**FINAL
ENGINEERING EVALUATION/COST ANALYSIS
FOR THE CAUSEWAY AND DIKE
STRATFORD ARMY ENGINE PLANT
Stratford, Connecticut**

**U.S. Army Corps of Engineers
New England District
Concord, Massachusetts**

Foster Wheeler Environmental Corporation
Boston, Massachusetts

FIGURE 4-1
ALTERNATIVE 1
EE/CA FOR THE CAUSEWAY
NON-TIME CRITICAL REMOVAL ACTION
STRATFORD ARMY ENGINE PLANT

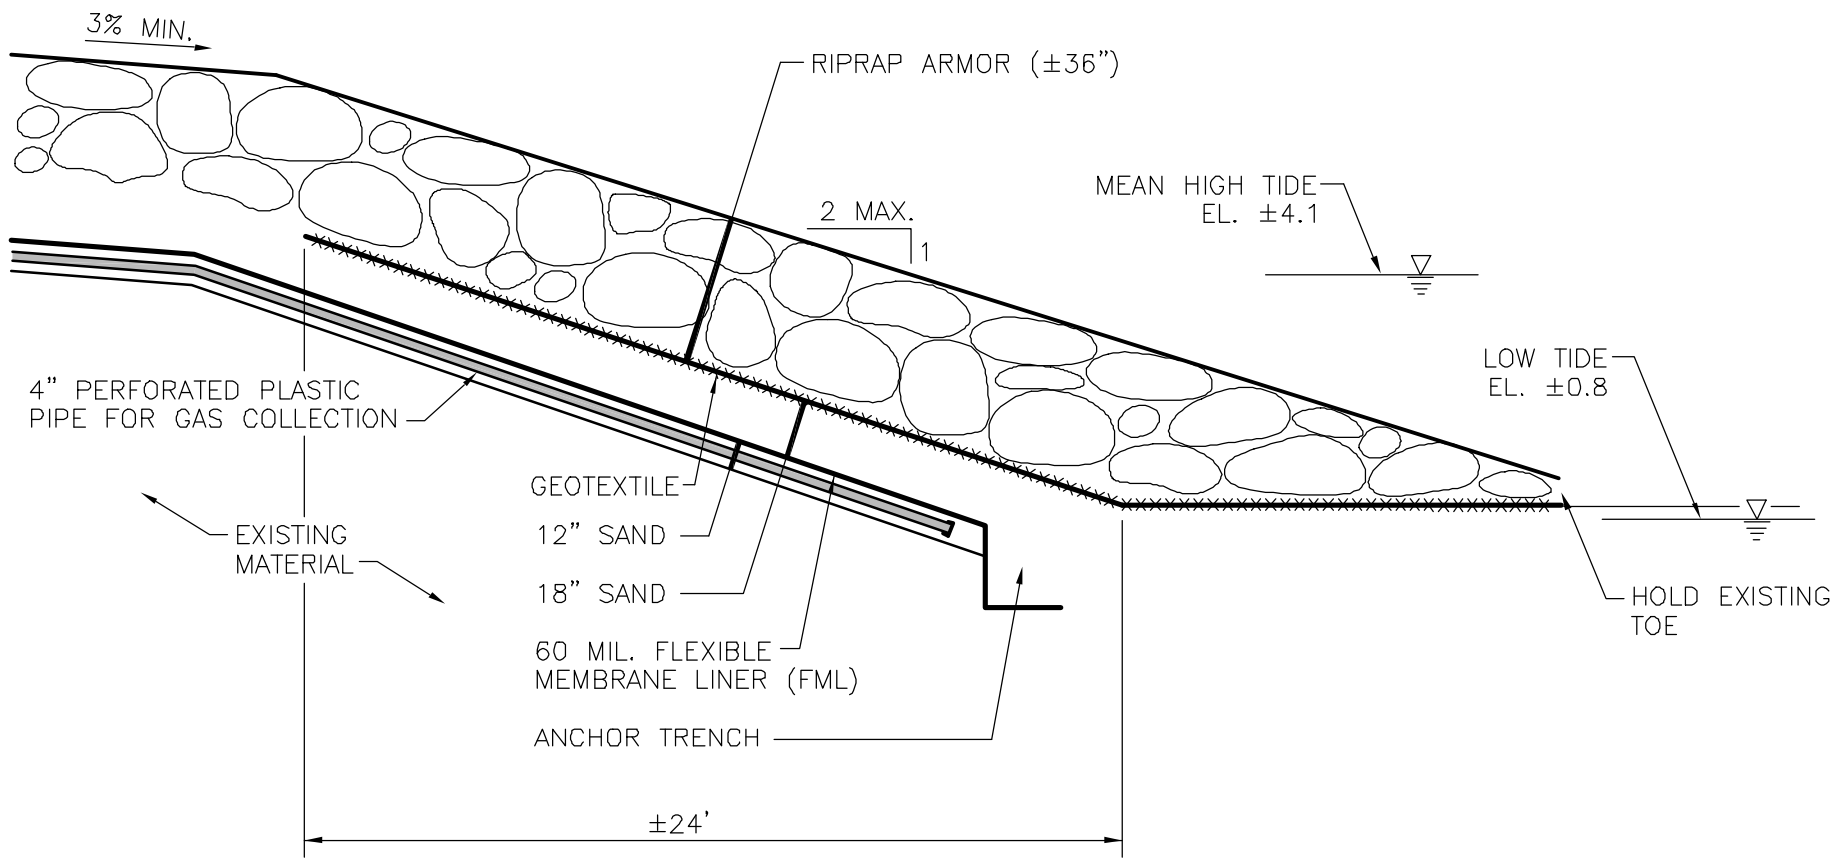
Alternative 1 - Figures 4-1 - The plans do not show the existing profile(s) for this alternative. Lacking this information, it is not possible to determine either the degree, if any, of encroachment into public trust and intertidal flats that this alternative represents or whether this alternative represents an ultimate change in the type and/or angle of side slope currently present on the causeway. It is our understanding that the causeway is already armored. If this is the case, replacement in place and in kind is acceptable and consistent with our enforceable policies regarding shoreline flood and erosion control structures. Additional information regarding the existing contours and make-up of the causeway side slopes in comparison to the proposed condition is necessary to determine the acceptability of this alternative.

**FIGURE 4-2
ALTERNATIVE 2
EE/CA FOR THE CAUSEWAY
NON-TIME CRITICAL REMOVAL ACTION
STRATFORD ARMY ENGINE PLANT**

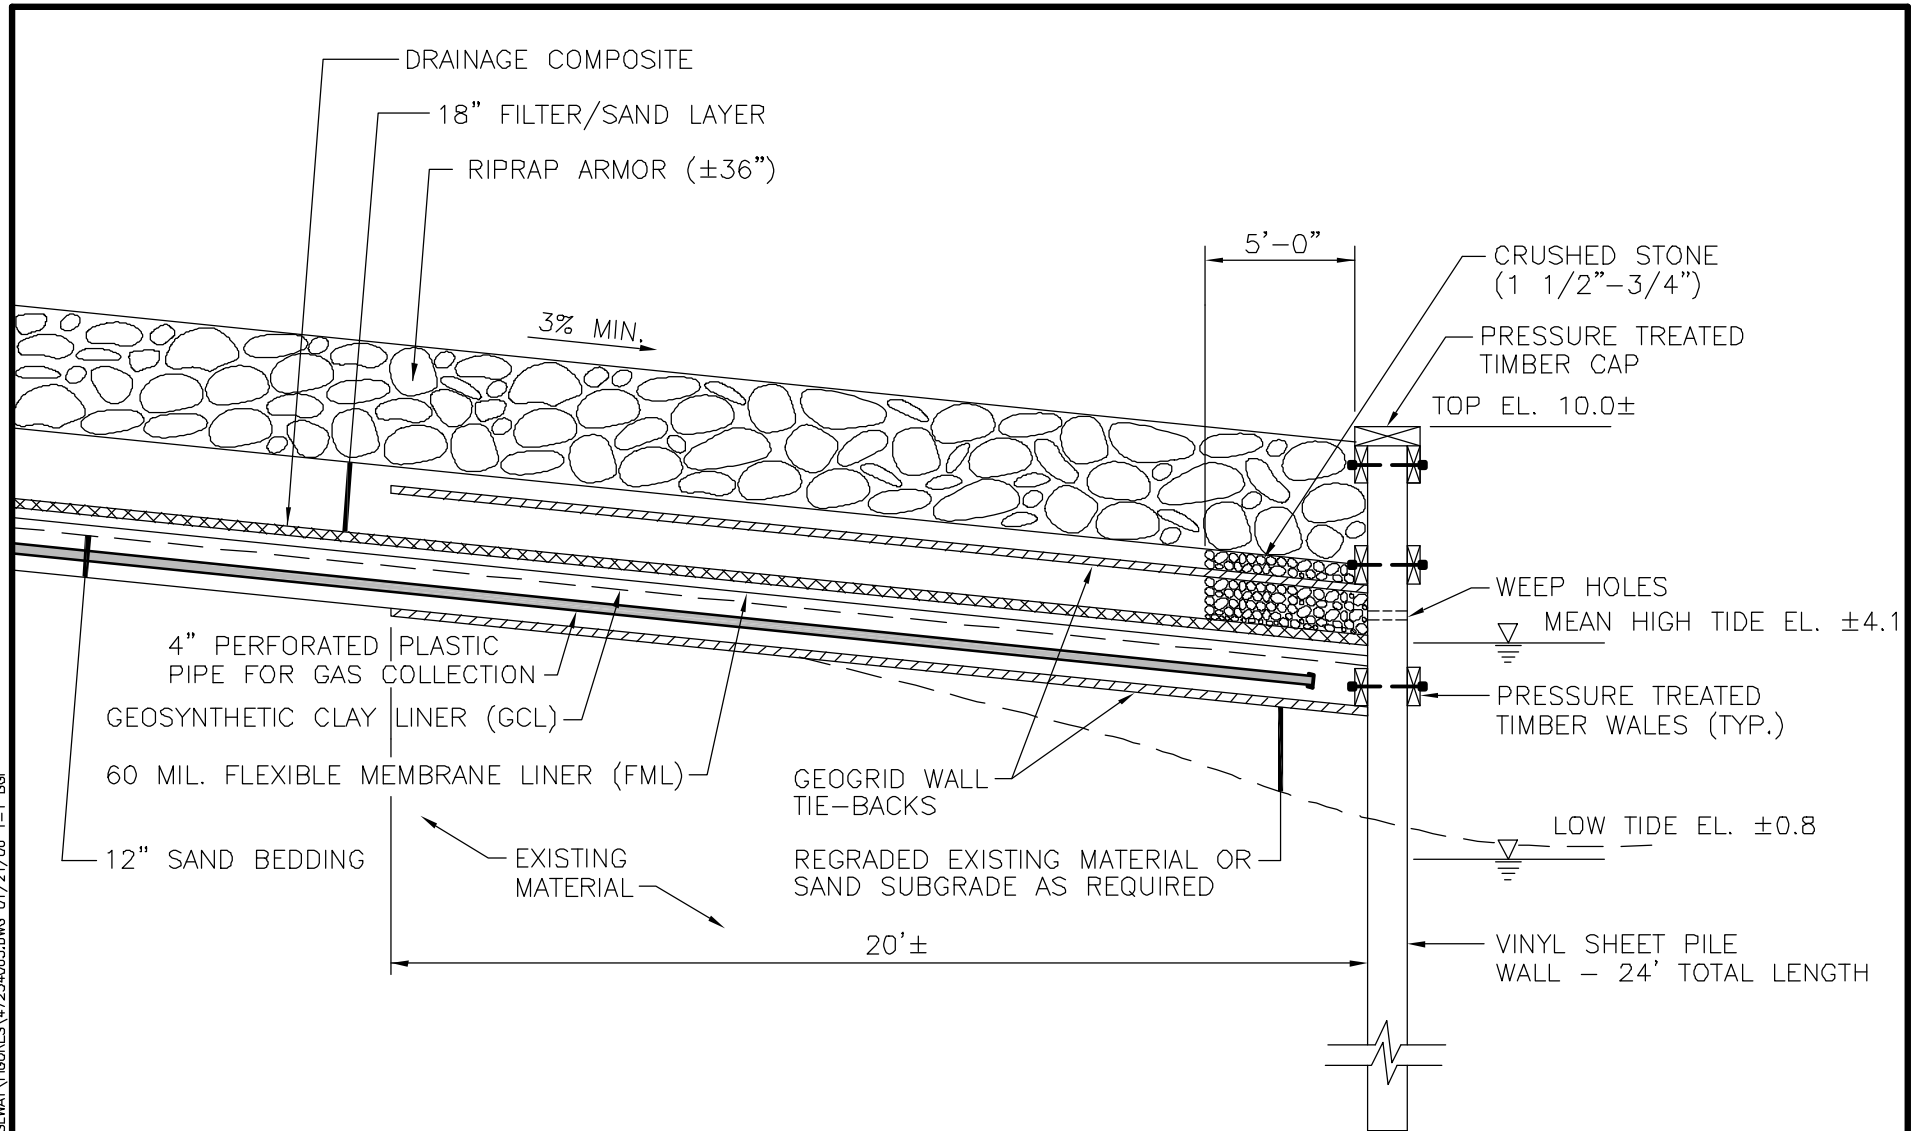
Alternative 2 - Figure 4-3 – Although the Army has indicated that this alternative is not the preferred project, we are compelled to reiterate our previous comments in the event that it comes under further consideration. Alternative 2 includes a vertical faced bulkhead. In prior discussion, we have discouraged the Army from considering such a structure as it constitutes a significant change from the existing condition. It also carries with it the potential to alter the localized wave energy patterns and we expect it would result in erosion of the intertidal flat.

**FIGURE 4-3
ALTERNATIVE 4
EE/CA FOR THE CAUSEWAY
NON-TIME CRITICAL REMOVAL ACTION
STRATFORD ARMY ENGINE PLANT**

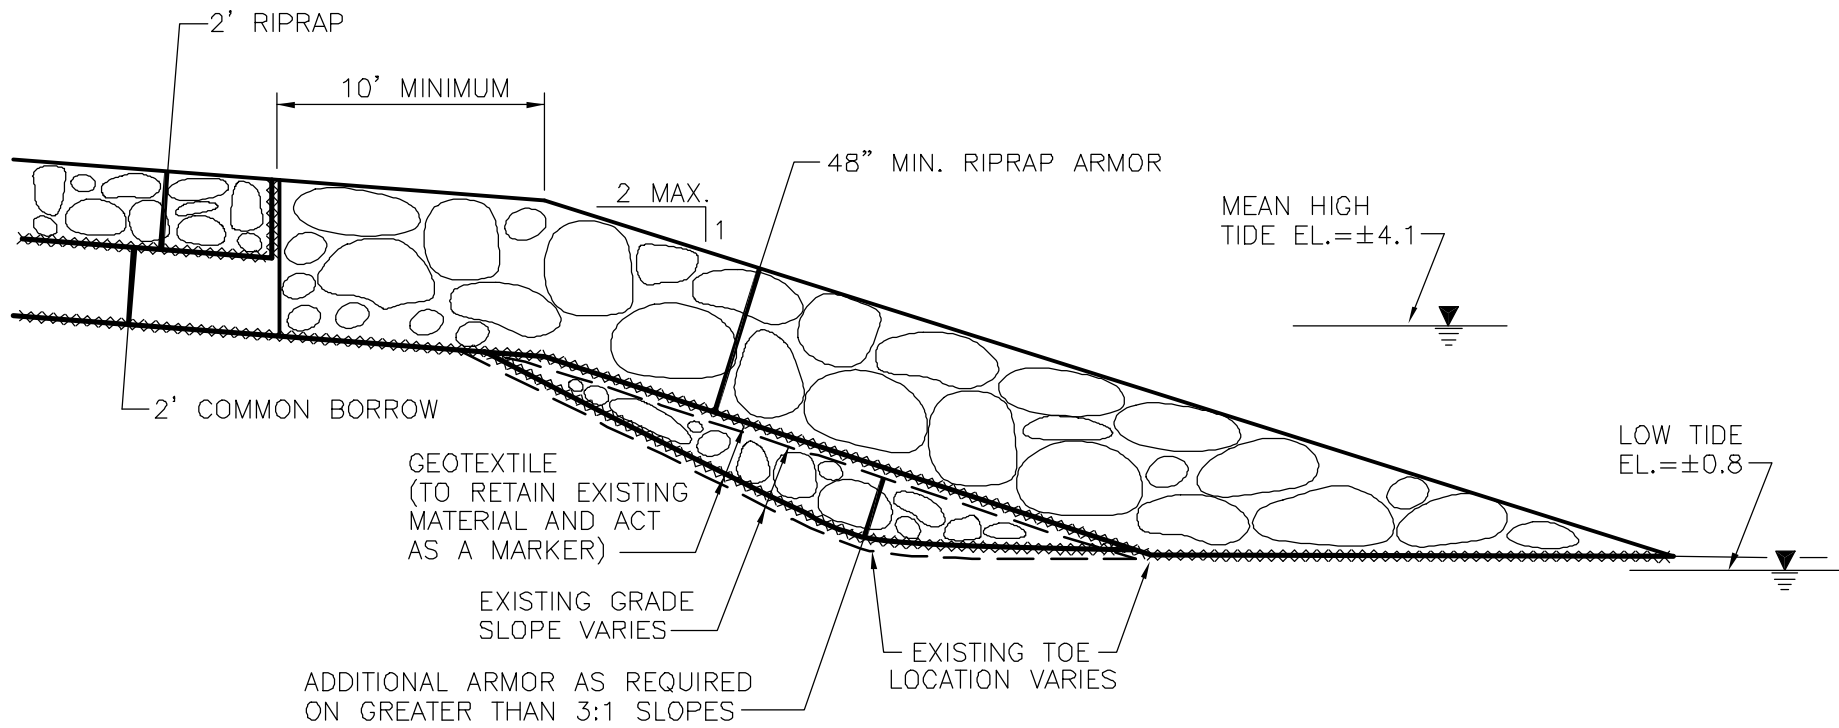
Alternative 4 - Figure 4-3 – The current draft EE/CA contains a new alternative, number 4, which is identified as the preferred alternative and is allegedly based, in part, on our prior comments. Unfortunately, the information provided regarding this alternative describes a design that is actually less consistent with Connecticut’s coastal management program than some of the alternatives considered for this project.

The description of this alternative includes removal of contaminated soil “hot spot areas” and containment of the remaining contaminated fill material within the causeway by constructing an erosion control cover system. Although the text indicated that following removal of the contaminated soil hot spot areas, the causeway would be regraded by cutting and filing existing material to establish base grades, these grading activities are not evident in Figure 4-3. Unlike Alternative 1, where the plans specifically note that the existing toe will be maintained by excavating existing material, Alternative 4 appears to include simply placing riprap over the existing side slopes. This method of armoring will result in significant and unacceptable encroachment beyond the high tide line and mean high water and into intertidal flats.

Additionally, Figure 4-3 is very confusing. It shows two existing slopes and only one proposed slope. There is no clear indication of where along the length of the causeway these apparently separate profiles are found. Nor is it clear why the proposed slope would not follow and reflect the existing condition. Regardless of the original profile, as discussed above, this alternative represents significant fill and encroachment beyond both the existing mean high water and mean low water lines. Although the high tide line is not shown on the plans, presumably fill is also proposed waterward of this critical elevation. It is not likely that a convincing demonstration can be made that this alternative, as currently proposed, is consistent with applicable enforceable policies and standards regarding shoreline flood and erosion control structures, filling in coastal waters and intertidal flats.

Based on both the tentative selection of Alternative 4 as the preferred alternative and its depiction provided in Figure 4-3, it does not appear that the Army fully understands the need to design a project that: 1) will not result in degradation of sensitive coastal resources, including the intertidal flats present at this site; 2) is consistent with the enforceable policies and standards regarding the construction of shoreline flood and erosion control structures; and 3) minimizes
